Service Bulletin

PRELIMINARY INFORMATION

Subject: Headlight Performance (BCM Calibration and Bulbs)

Models: 2015 GMC Sierra
2014 GMC Sierra 1500

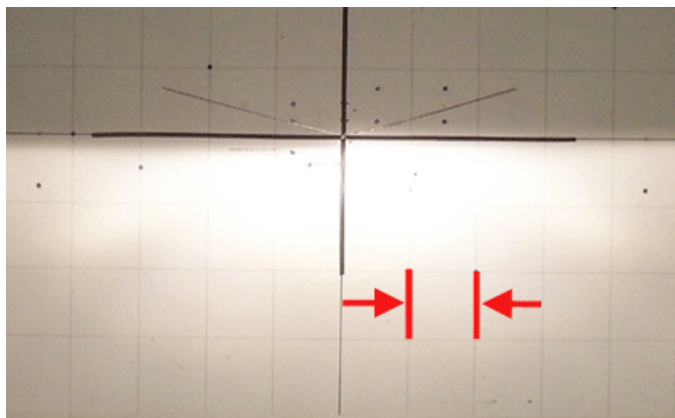
2. Replace both headlight bulbs with updated bulb part number 23342527. IMPORTANT: Verify the correct bulb is being installed by confirming the following markings on the bulb:

1. 28432
2. HIR2+30
